Application for Planning Approval

DA2026/022

39A ANDREW STREET, BRIGHTON

MULTIPLE DWELLINGS (1 EXISTING, 34 NEW) & ASSOCIATED INFRASTRUCTURE

3 SUN SHADOW DIAGRAM_1100AM
Scale 1:600

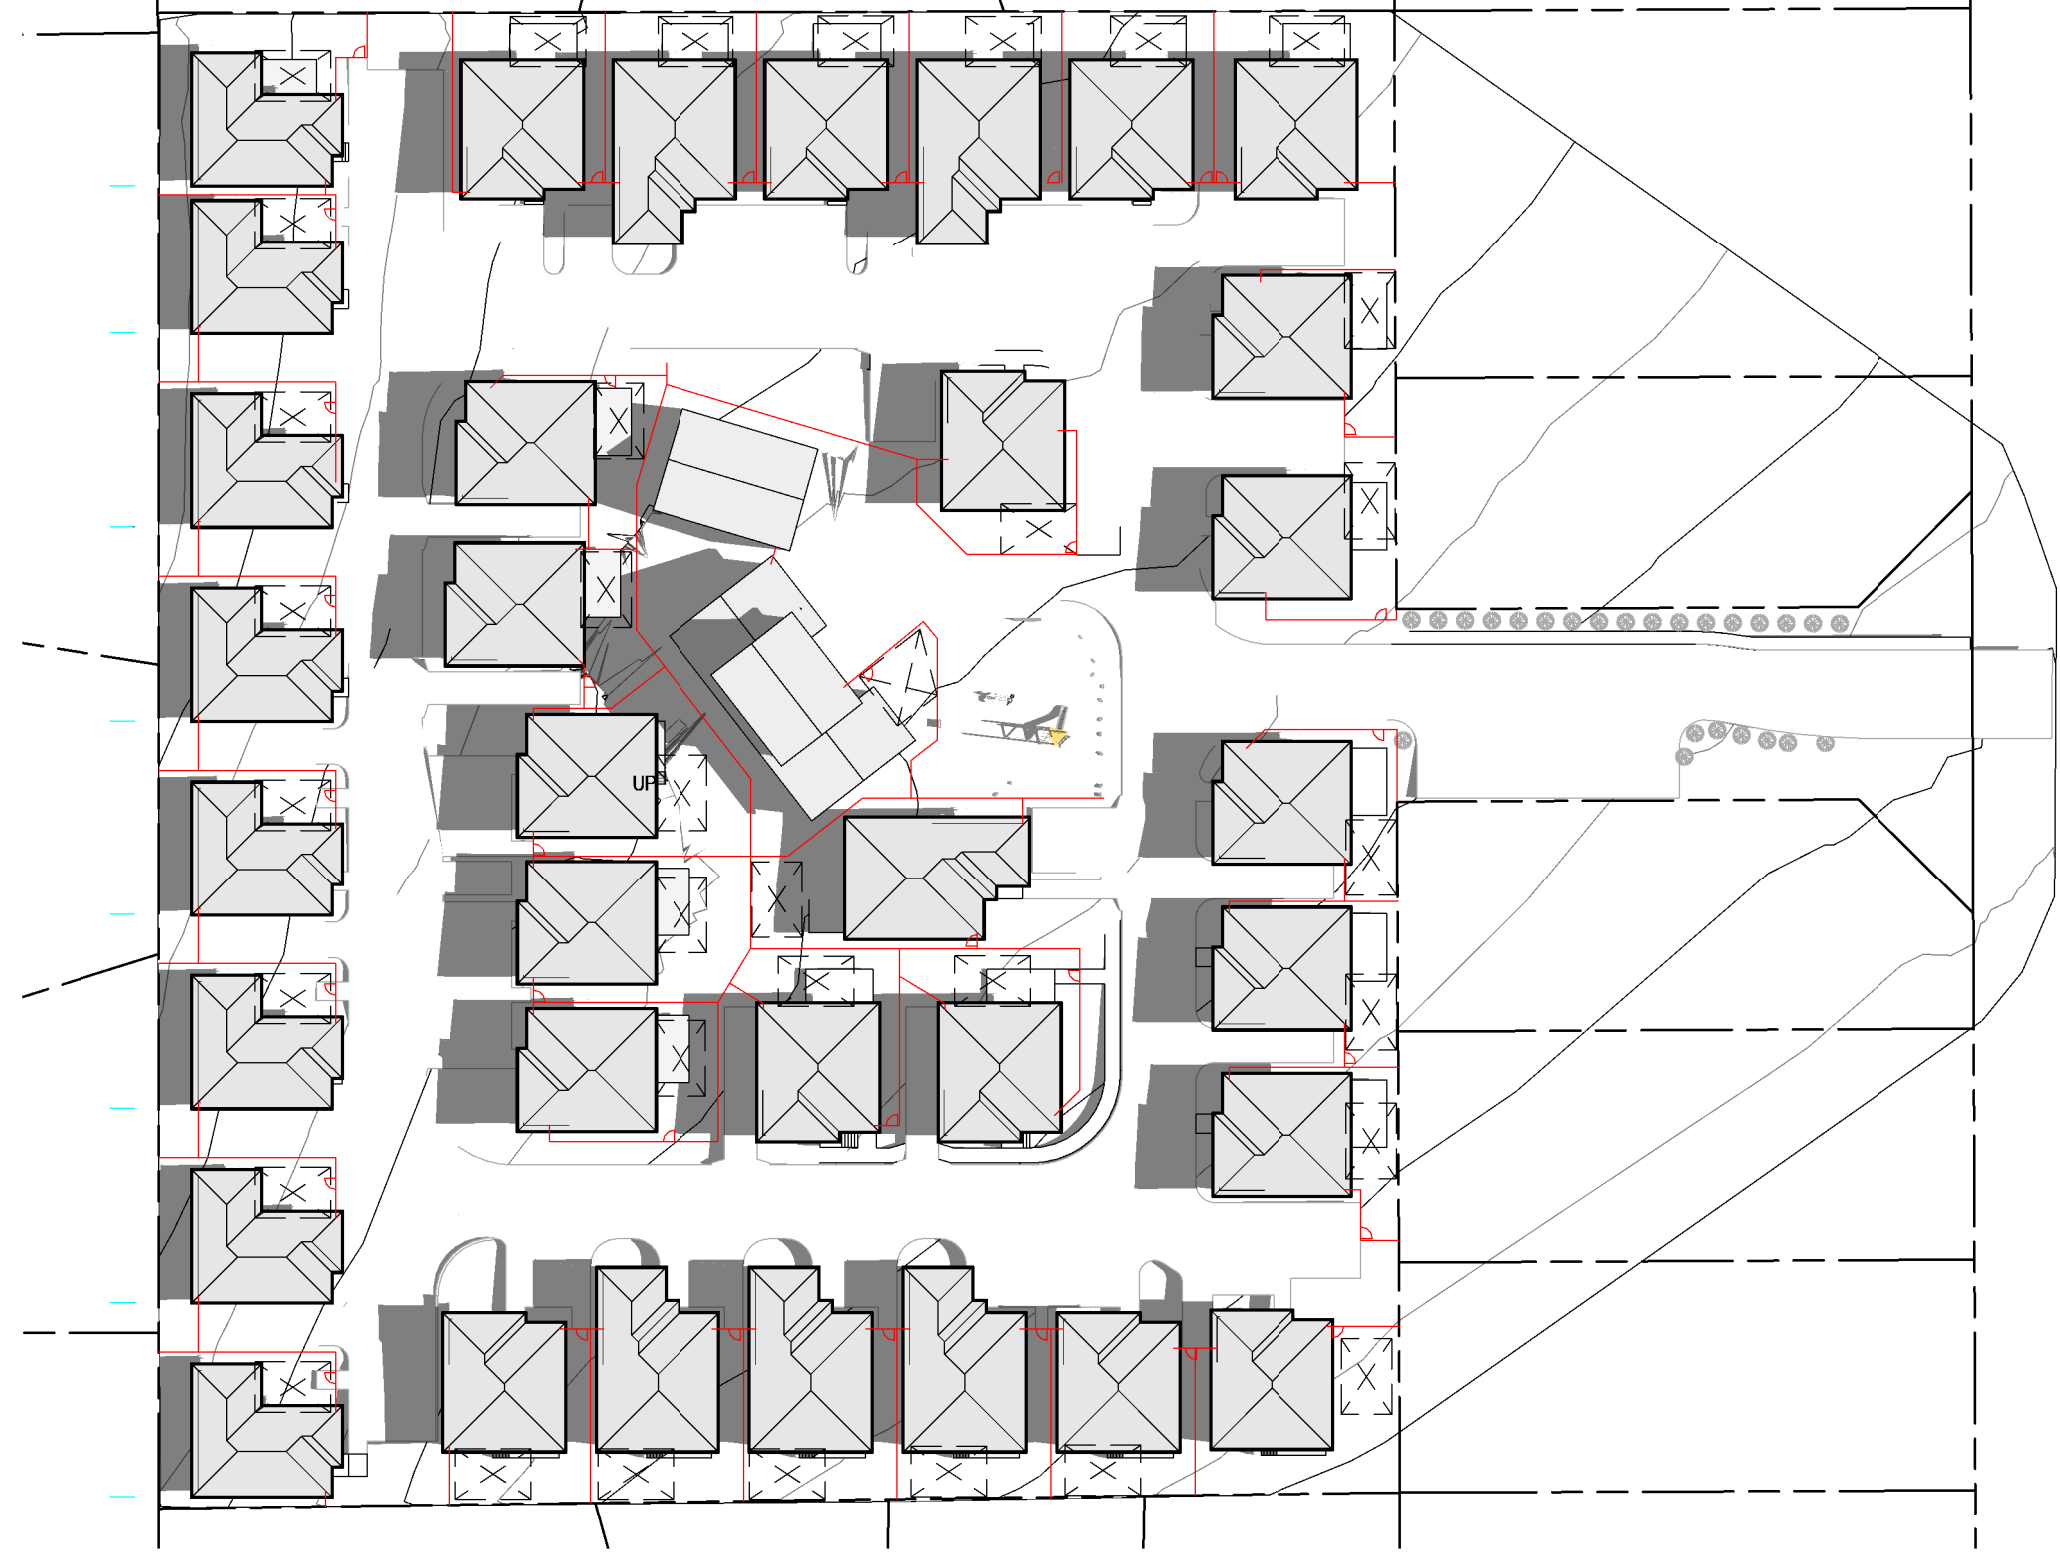
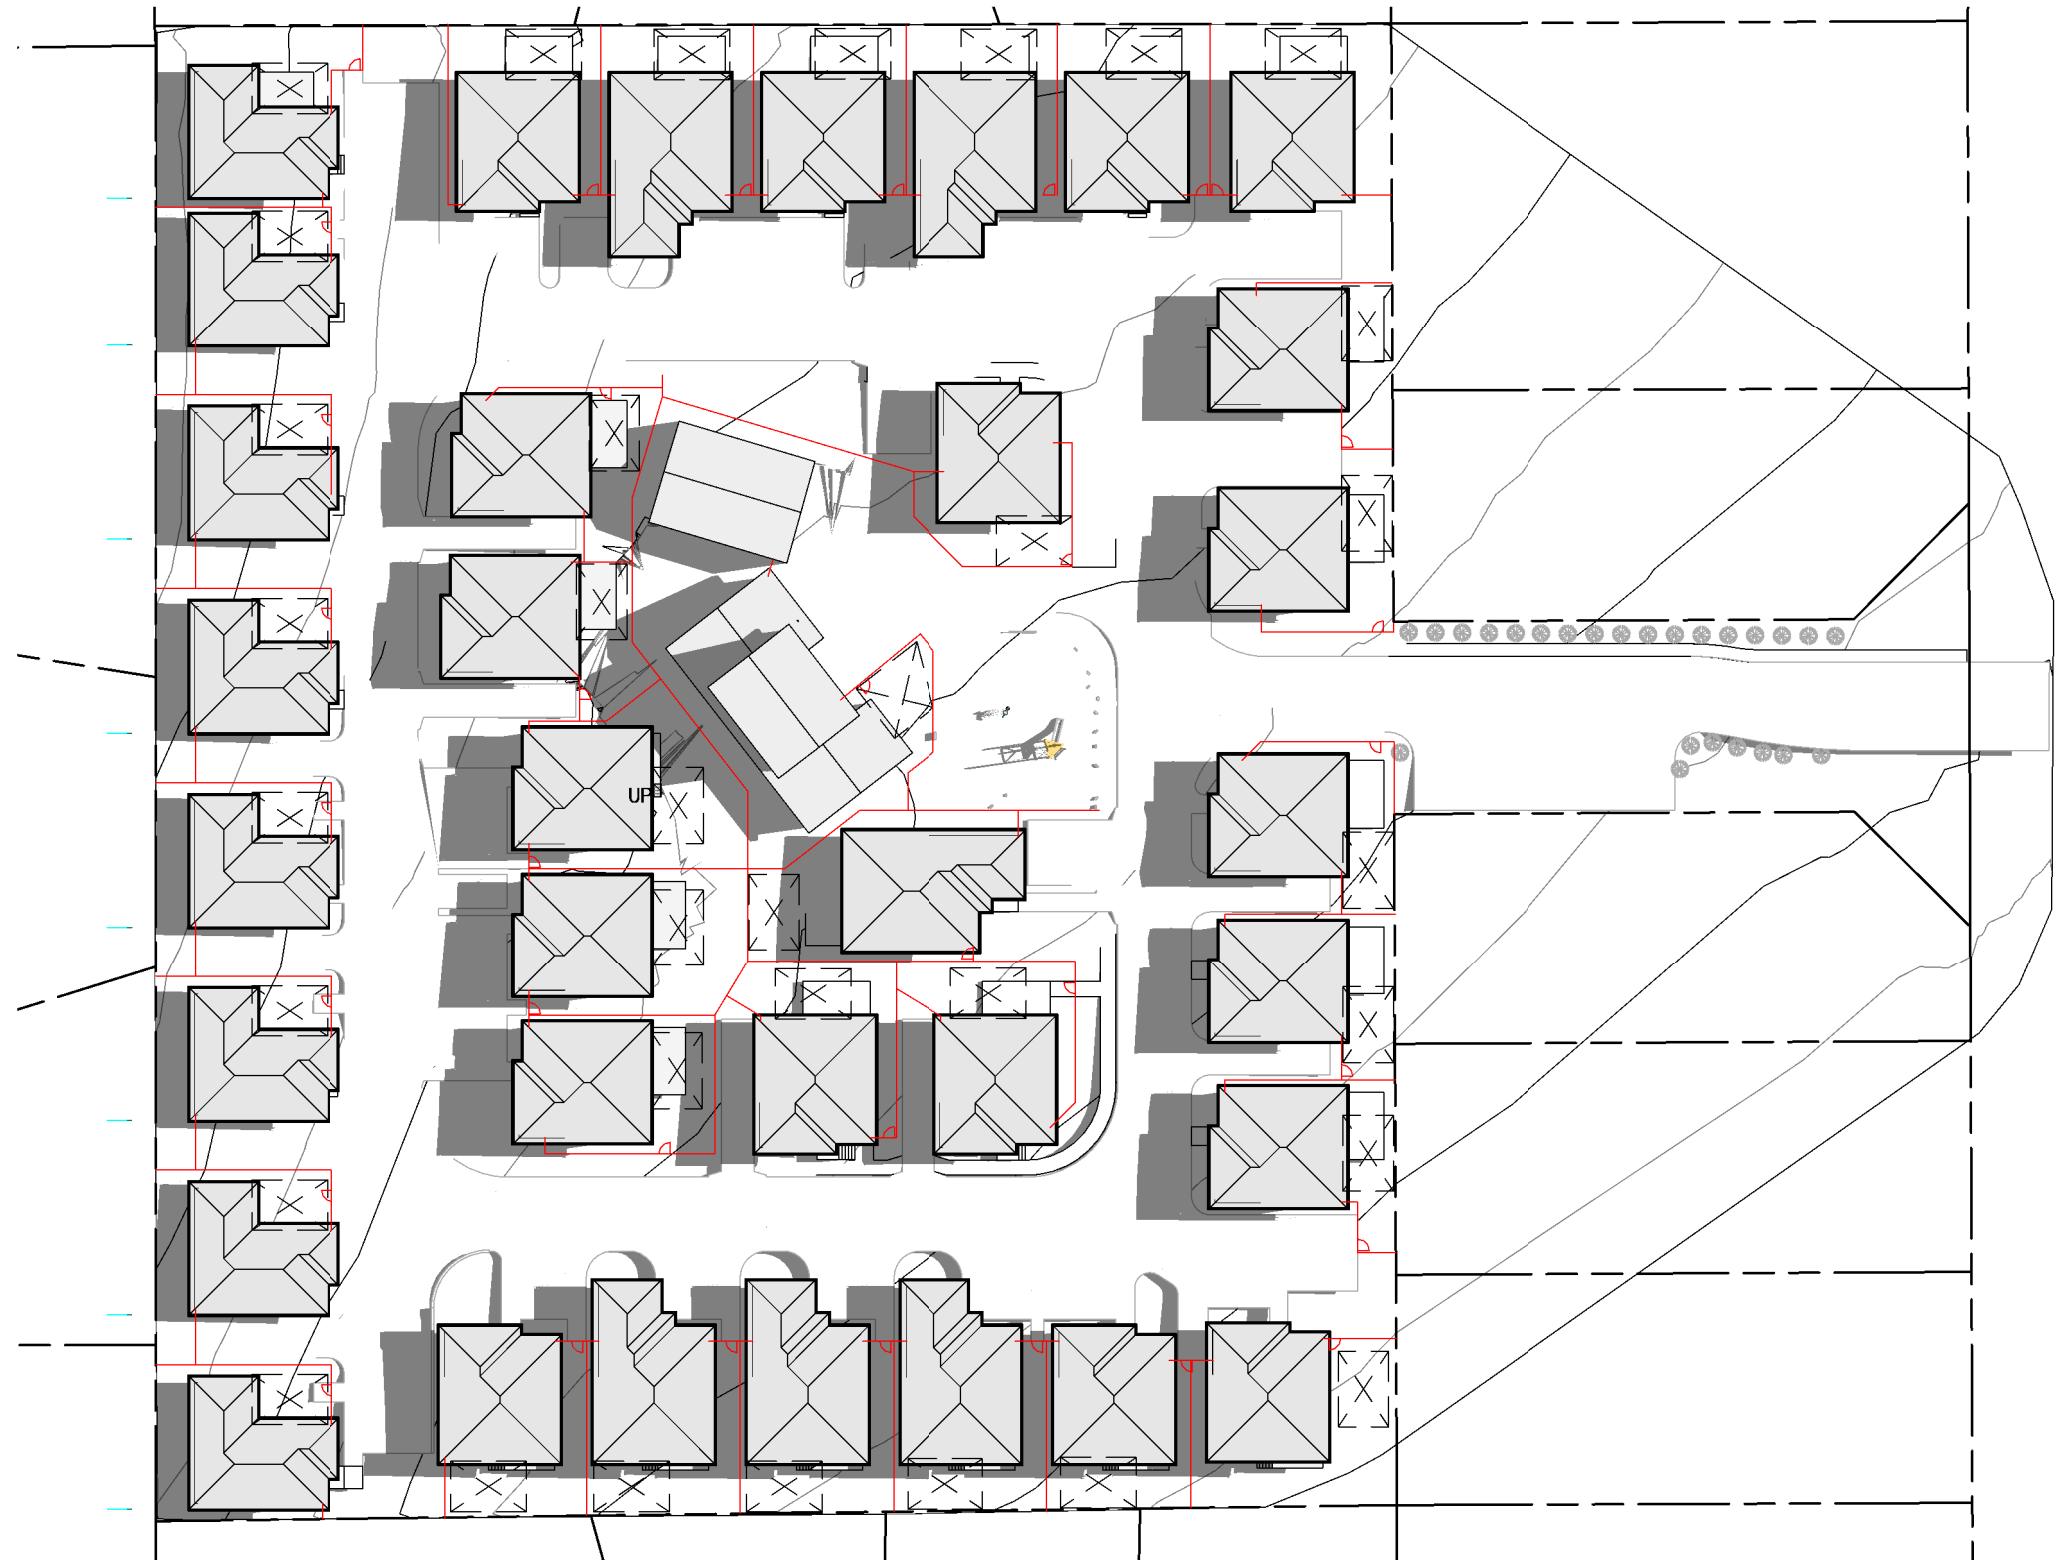
Please provide a planning report addressing each of the development standards, and where the proposed application does not satisfy the acceptable solution (eg 8.4.2 A1; 8.4.2 A3; 8.4.4 A1), include a written response to the performance criteria.

8.4.4 – A1 – The shadow diagrams provided in Drawing DA20 demonstrate that all proposed units (POS) will receive a minimum of 3 hours of direct sunlight between 9:00 am and 3:00 pm on 21 June. Accordingly, the proposed development satisfies the requirements of Acceptable Solution 8.4.4–A1(b).
